## SERVICE BULLETIN

POWER PLANT - EEC HARNESS FAN/CORE - DELETION OF CLIPPING AT VSVA AND PMA HARNESS CONNECTORS AND INTRODUCTION OF WIRE LOCKING TO SECURE CONNECTORS - V2500-A1=8 - V2500-A5=4 - MOD.ENG-71-0111

# V2500-ENG-71-0111

Location of EEC fan harness and clipping position 1094  
Fig.1, Sheet 1 of 2

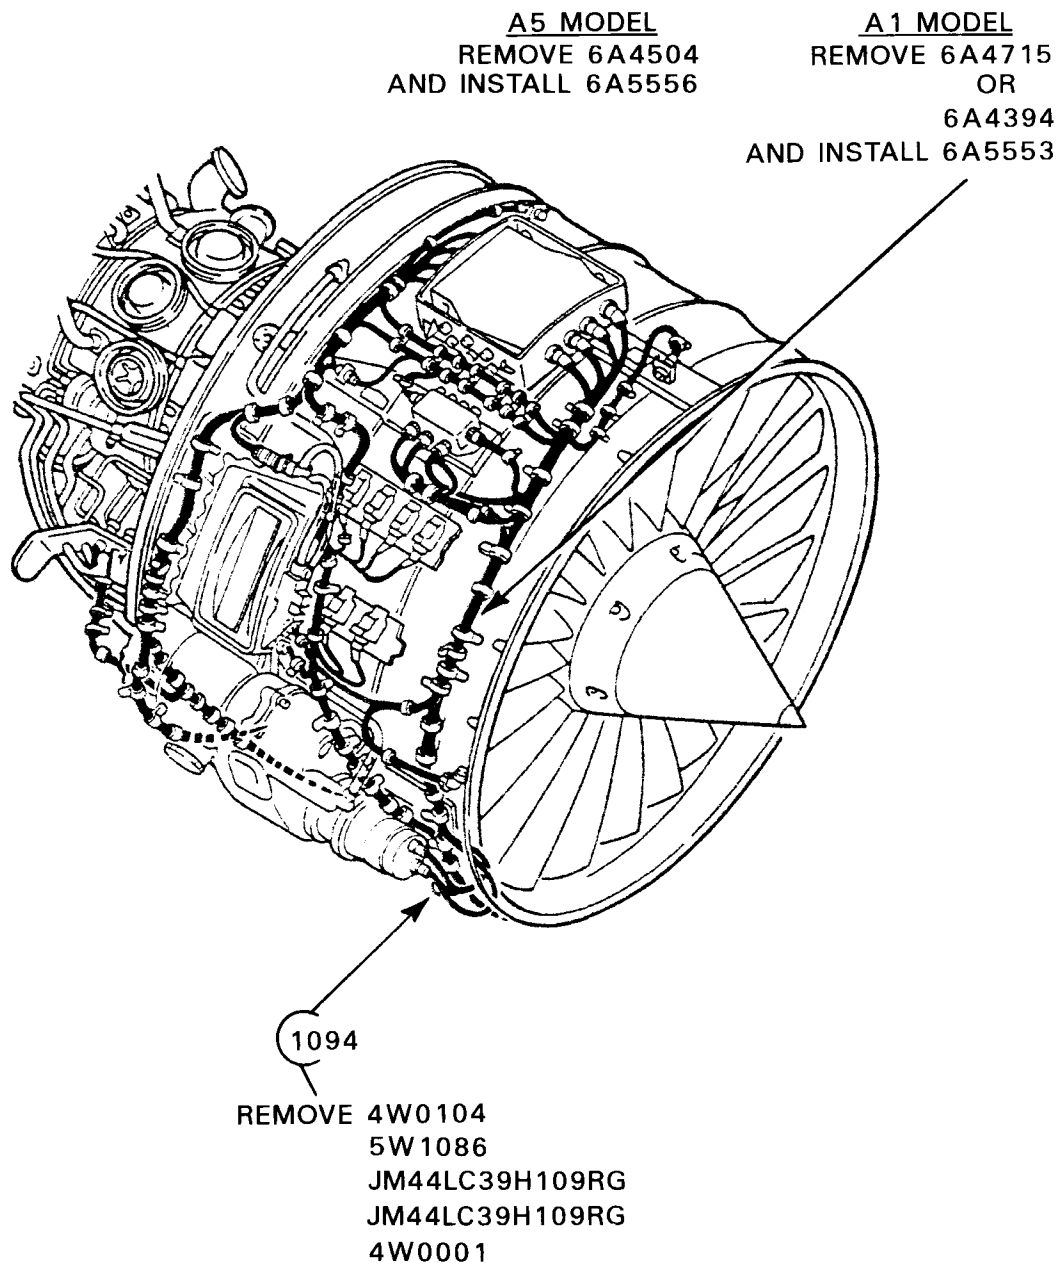
- (a) A new EEC fan harness and a new EEC core harness featuring wire locking holes in the connectors to the PMA and VSVA.
- (b) At the PMA the connectors 4005EV-A and 4005EV-B are wire locked together and the clamps and attaching parts at CP 1094 are deleted.
- (c) At the VSV actuator torque motor, connectors 4022KS-C and 4022KS-B are wire locked together and the clamps and attaching parts at CP 5798 are deleted.
- (d) At the VSV actuator L.V.D.T. cover location, the connectors 4022KS-A and 4022KS-D are wire locked together and the clamps and associated support bracket, 5W2166, and attaching parts at CP 6060/6061 are deleted.

- (1) Locate the back to back clipping arrangement at the VSVA clipping positions 5798, 6060/6061 and the PMA clipping position 1094.
- (2) Remove the 4W0001 nut, 4W0107 bolt, two 5W1086 washers and two JM44LC39H106RG clamps from the VSVA harness backshells at clipping position 5798. Refer to Figures 1 and 2.
- (3) Remove the two 4W0001 nuts, two 4W0107 bolts, four 4W2621 washers, 5W2166 bracket and two JM44LC39H110RG clamps from the VSVA harness backshells at clipping position 6060/6061. Refer to Figures 1 and 2.
- (4) Remove the 4W0001 nut, 4W0104 bolt, two 5W1086 washers and two JM44LC39H109RG clamps from the PMA harness backshells at clipping position 1094. Refer to Figures 1 and 3.
- (5) Remove the connectors at the input and output sides of the VSVA and at the PMA.

View showing VSVA connectors  
Fig.4

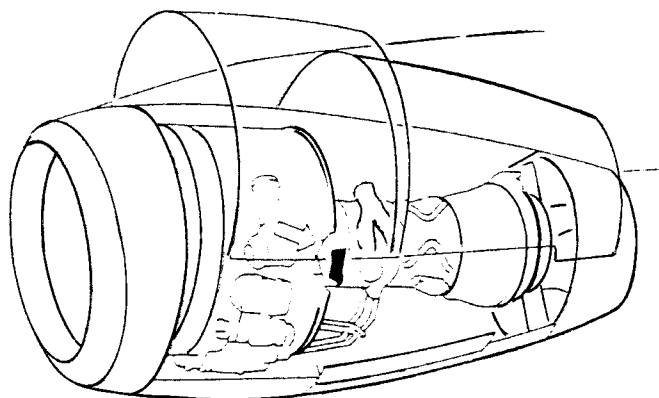
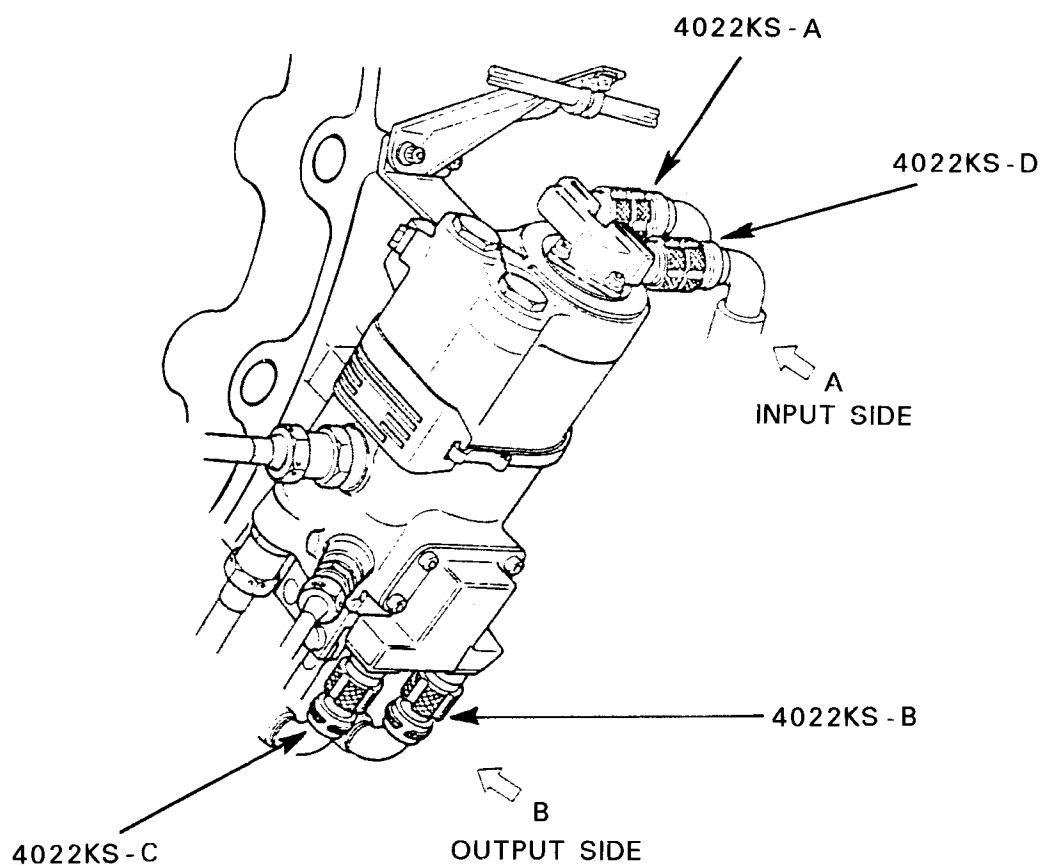
- (1) Install the input and output side connectors to the VSVA and tighten the retaining collar on each connector to the required torque value. Refer to Figure 4.
- (2) Install the connectors to the PMA and tighten the retaining collar on each connector as instructed in the Aircraft Maintenance Manual, TASK 73-22-38-400-010, SUBTASK 73-22-38-430-401.
- (3) Safety the four VSVA connectors and the two PMA connectors with CoMat 02-126 lockwire, as instructed in the Aircraft Maintenance Manual, TASK 70-40-11-911-012, Example 22.

CONNECTOR	TORQUE TIGHTEN TO
4022KS -A	12lbf/ins
4022KS -B	8lbf/ins
4022KS -C	8lbf/ins
4022KS -D	12lbf/ins
